SUBMITTAL IDENTIFICATION SHEET

WEBSTER UNIVERSITY ISB
PROJECT NAME

DATE: 1/25/2017
JOB: 04437A, B, C, D

COPIES	DATE	NO.	DESCRIPTION
1	1/25/17	04437AR1-E2 and 04337BR1-E4	Rough-In & Elevation Shop Drawings
1	1/25/17	04437DETAILS1 & 04437DETAILS2	Cabinet Sections
1	1/25/17	04437OHSC	OHSC detail/quantities Sheet
1	1/25/17	Set	Project Data Document

CT7833MSC

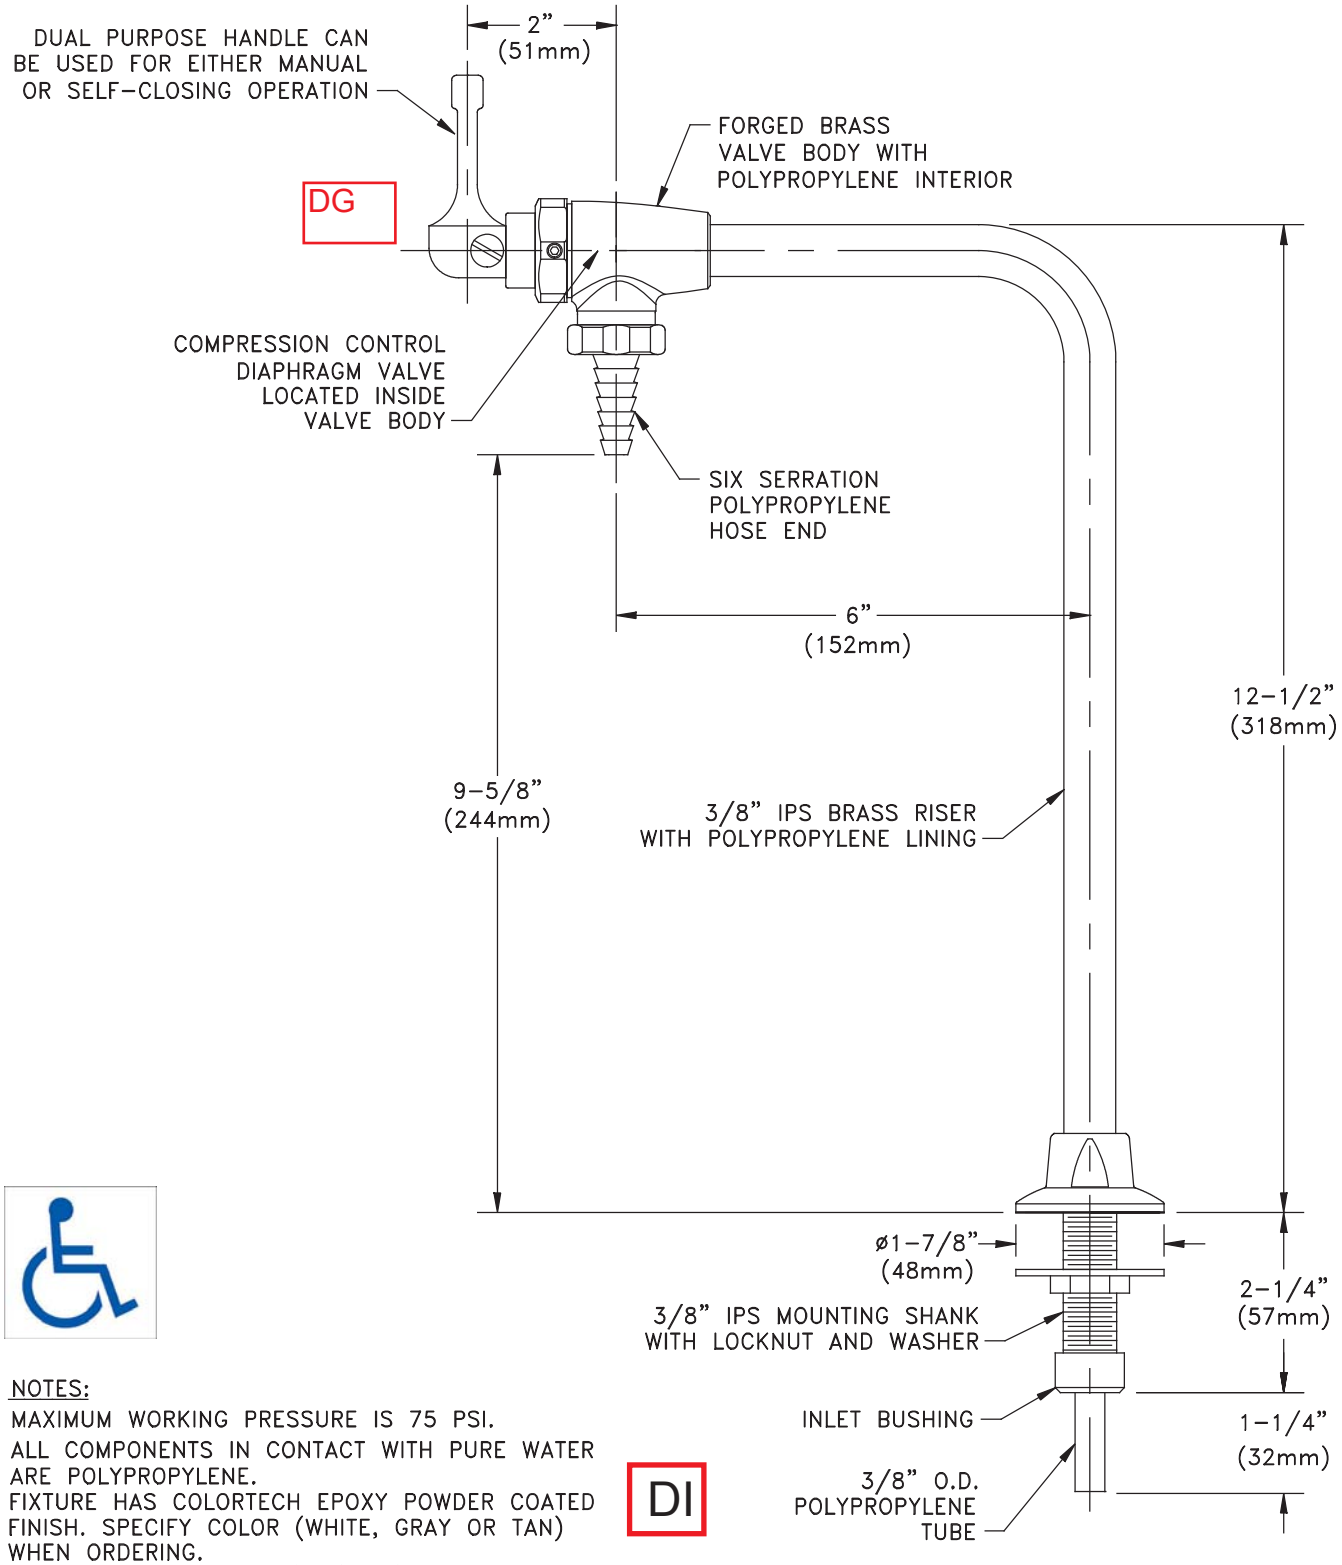
-EW, DH & PRE-RINSE FIXTURE APPROVAL ON HOLD.
